Distr.: General  
31 January 2011

**Economic Commission for Europe****Inland Transport Committee****World Forum for Harmonization of Vehicle Regulations****Working Party on General Safety Provisions****100<sup>th</sup> session**

**Regulation No. 125 (Forward field of vision of drivers)****Proposal for amendments to Regulation No. 125 (Forward field of vision of drivers)****Submitted by the expert from Japan \***

Figure 1

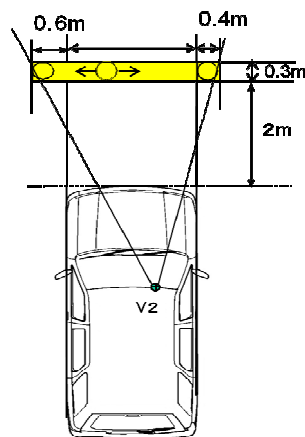
Insert new paragraph 5.1.4 (including new figure 1), to read:

"5.1.4. A 1.2 m-tall cylindrical object with a diameter of 0.3 m that is situated inside the space bounded by a vertical plane located 2.0 m in front of the vehicle, a vertical plane located 2.3 m in front of the vehicle, a vertical plane located 0.4 m from the driver's side of the vehicle, and a vertical plane located 0.6 m from the opposite side of the vehicle shall be at least partially visible when viewed directly from V2 (see figure 1), regardless of where the object is within that space, unless it is invisible due to a blind spot(s) created by the A pillars, windscreen wipers, or steering wheel.

2. This proposal is a modified version of ECE/TRANS/WP.29/GRSG/2010/4, which was submitted for the purpose of preventing road accidents due to the inability of drivers of

vehicles with an extremely high eye point to view small vehicles (e.g., motorcycles) in front.

3. ECE/TRANS/WP.29/GRSG/2010/4 proposed to add a new provision to paragraph 5.1.3. However, its relation to the area S of paragraph 5.1.3.1., proposed in ECE/TRANS/WP.29/GRSG/2009/20, was unclear. In order to clarify that relation, this proposal proposes to delete the language that had been added to paragraph 5.1.3. and to insert a new paragraph 5.1.4., thereby making it clear that the new provision is independent from the provision on the area S in paragraph 5.1.3.1.

4. The drivers of vehicles with an eye point of regular height, that satisfy paragraph 5.1.3., are able to view small vehicles in front. But with vehicles with an extremely high eye point, it can be difficult for their drivers to view some small vehicles even when paragraph 5.1.3. is met. New paragraph 5.1.4. can prevent this problem.

5. The wording "there should be no obstruction" was proposed in ECE/TRANS/WP.29/GRSG/2010/4. But the original objective of the proposal is to make it possible for drivers to view objects on the road (e.g., motorcycles) with a size equal to or more than the specified size. To be in line with that objective, this proposal changes the wording to "a 1.2 m-tall cylindrical object with a diameter of 0.3 m ... shall be at least partially visible".
